# DESIGN COMMISSION

**CITY OF MERCER ISLAND  
DESIGN COMMISSION  
STUDY SESSION STAFF REPORT  
MAJOR NEW CONSTRUCTION**

| Project:         | Xing Hua Group Ltd Mixed-Use Project (DSR18-018)   |

**MERCER ISLAND DESIGN REVIEW STUDY SESSION #2**

# **APPENDIX: SUPPORTING INFORMATION**

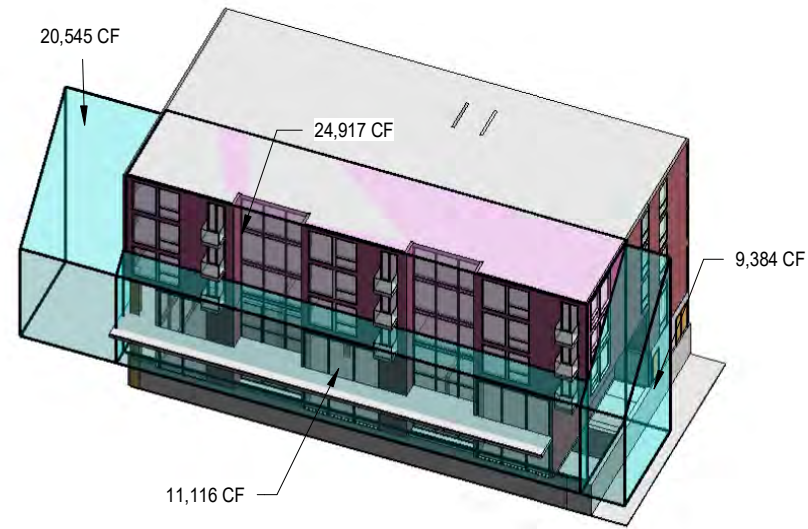
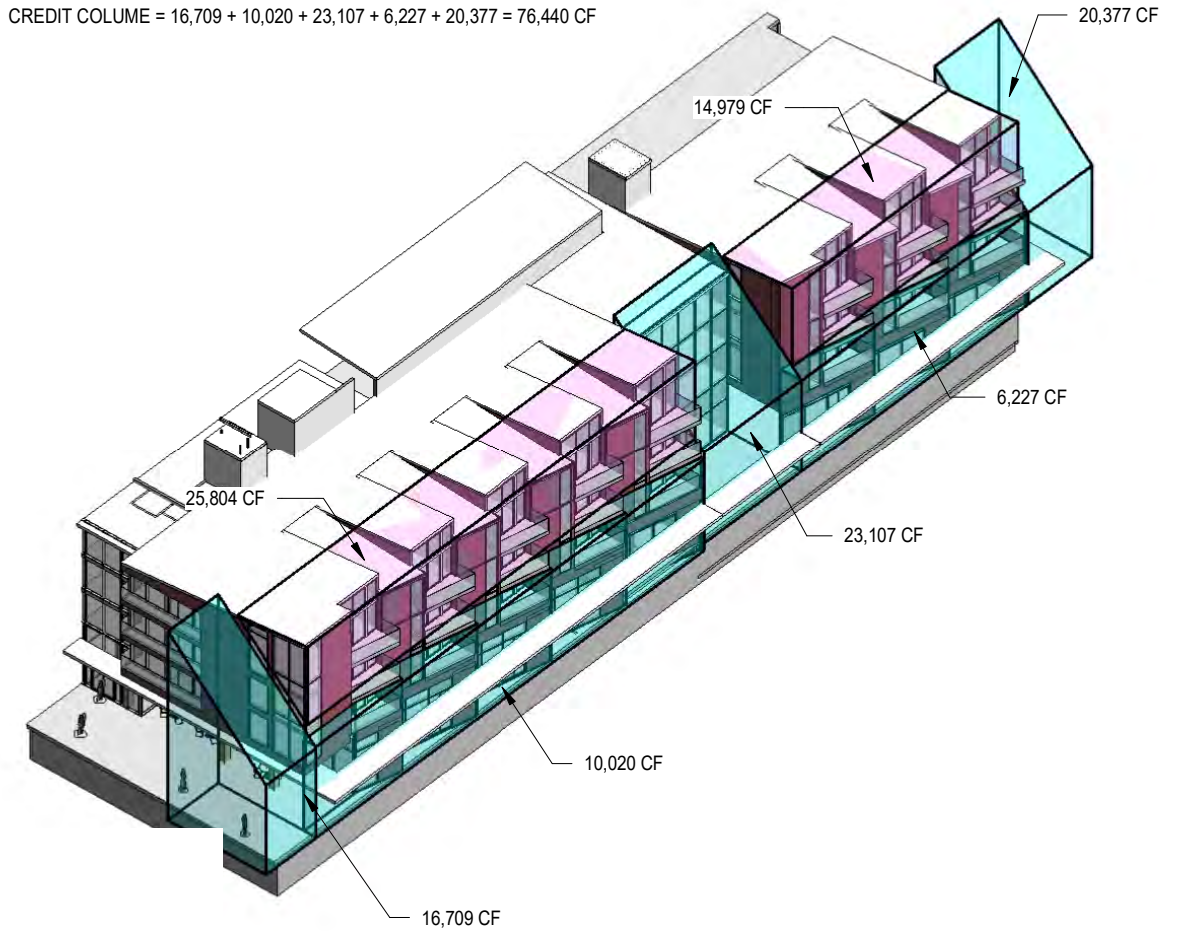
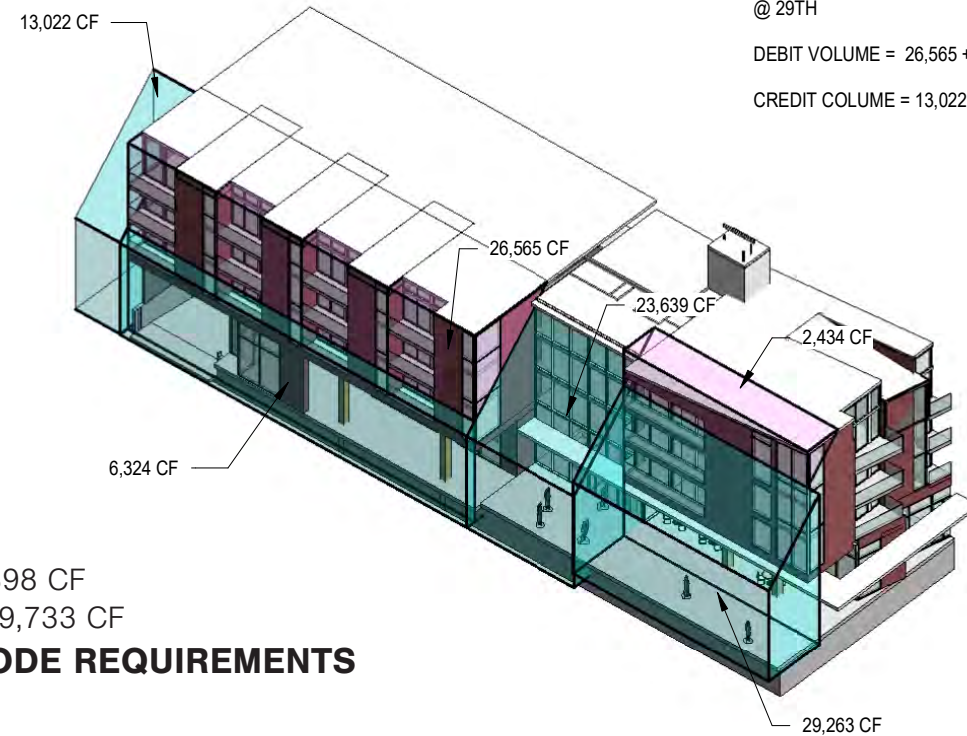
The applicant has provided a new detail that demonstrates how the total credit volume greatly exceeds the debit volume to comply with the daylight plane standard. The credit volume equals 189,733 cubic feet, and the debit volume is 80,898 cubic feet.

@ 77TH  
 DEBIT VOLUME = 24,917 CF  
 CREDIT COLUME = 20,545 + 11,116 + 9,384 = 41,045 CF

@ 78TH  
 DEBIT VOLUME = 25,804 + 14,979 = 40,783 CF  
 CREDIT COLUME = 16,709 + 10,020 + 23,107 + 6,227 + 20,377 = 76,440 CF

@ 29TH  
 DEBIT VOLUME = 26,565 + 2,434 = 28,999 CF  
 CREDIT COLUME = 13,022 + 6,324 + 23,639 + 29,263 = 72,248 CF

TOTAL DEBIT VOLUME = 40,783 + 28,999 + 11,116 = 80,898 CF  
 TOTAL CREDIT VOLUME = 76,440 + 72,248 + 41,045 = 189,733 CF

**WE ARE 108,835 CF ABOVE THE LAND USE CODE REQUIREMENTS**
